TO: Mayor Trey King, City of Dacula
ATTN TO: Brittini Nix, Director of Planning and Economic Development, City of Dacula
RE: Development of Regional Impact Review
FROM: Mike Alexander, Director, ARC Center for Livable Communities

Name of Proposal: Harbin 2 DRI 3700

Description: A DRI review of a proposal to construct a mixed-use development with 137,300 SF of commercial space, 304 multi-family units, and 53 townhouses on a 54-acre site on Harbins Road south of University Parkway in the city of Dacula.

WWP ACQUISITION, LLC
 1958 MONROE DRIVE NE ATLANTA, GEORGIA 30324, PHONE: 404-872-8666
CONCEPTUAL MASTER PLAN

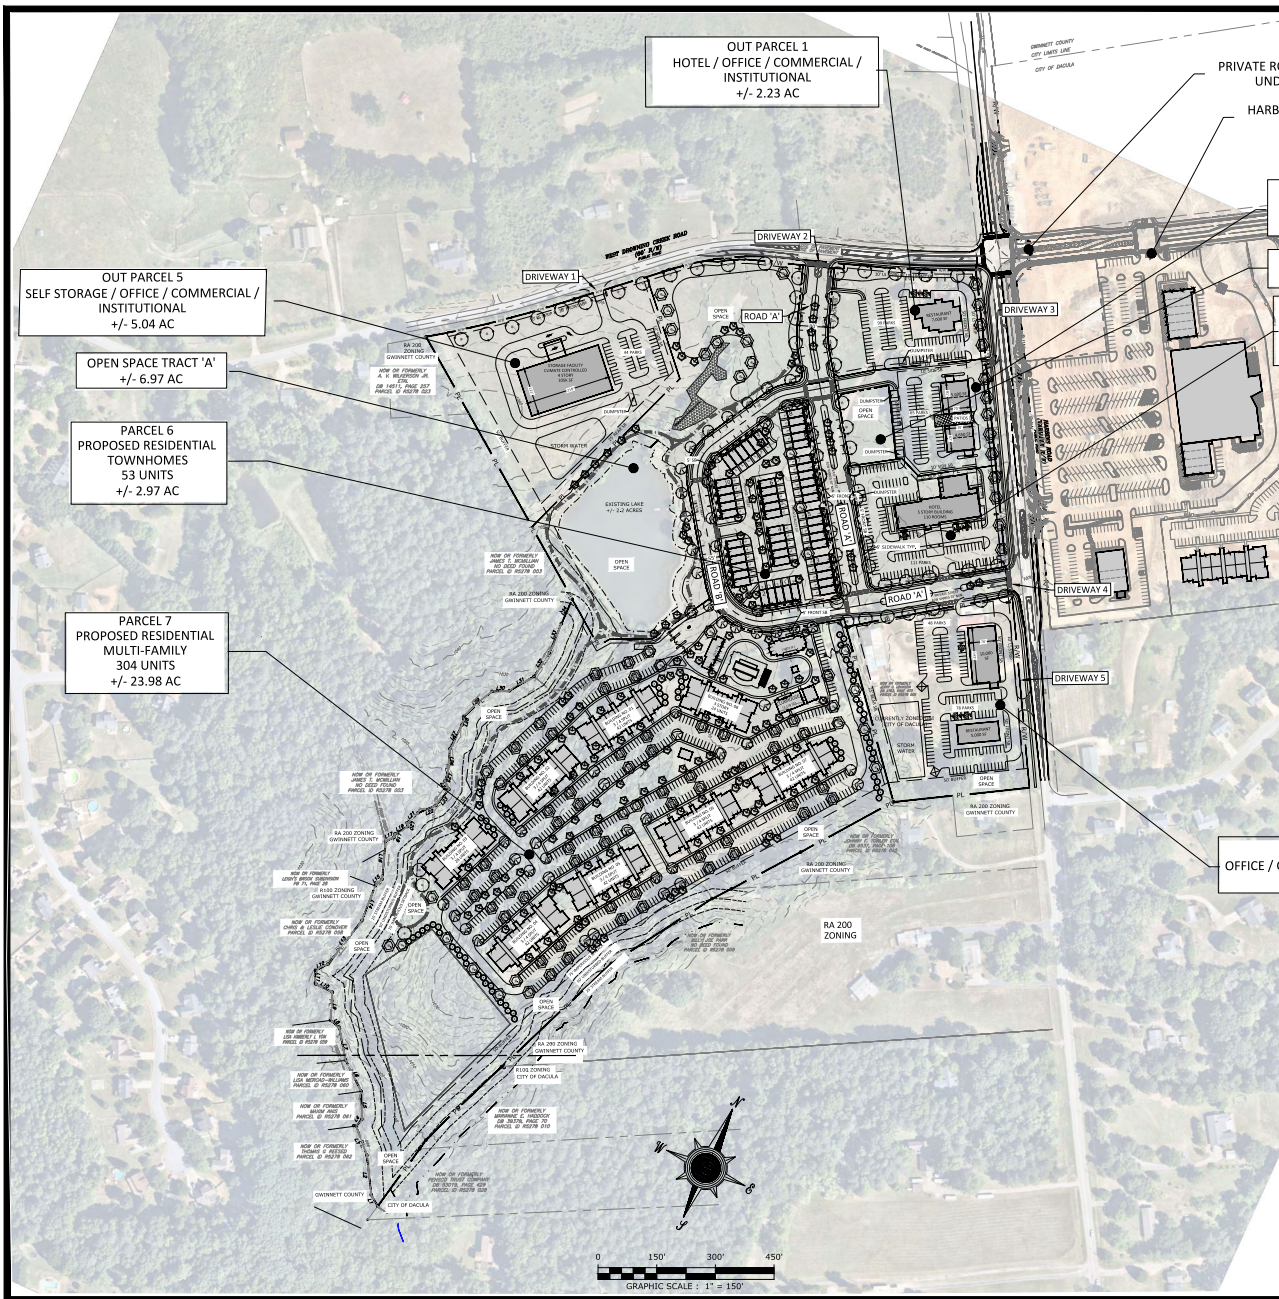
No EV charging spaces appear to be included; provision of adequate EV charging spaces would be supportive of regional EV infrastructure policies.

Incorporation of green stormwater and heat island mitigation designs for the approximately 1,056 surface car parking spaces proposed would be supportive of regional environmental policies.

Additional retention of existing trees on the site would be desirable and in keeping with regional goals regarding carbon sequestration and climate change/heat island effect mitigation. A substantial portion of the site along Palm Creek is shown as open space and water quality protection buffer areas. Designation of

this area as managed open/conservation space could meaningfully reduce the overall impact of the project. There may be potential opportunities for linking these fragmented undeveloped areas with adjacent undeveloped or protected areas to ensure their maintenance and potential use for recreation or habitat preservation.

The project can support The Atlanta Region's Plan in general by incorporating other aspects of regional policy, including green infrastructure and/or low-impact design, e.g., pervious pavers, rain gardens, vegetated swales, etc., in parking areas and site driveways, and as part of any improvements to site frontages.

Incorporation of green stormwater and heat island mitigation designs for the approximately 1,056 surface car parking spaces proposed would be supportive of regional environmental policies.
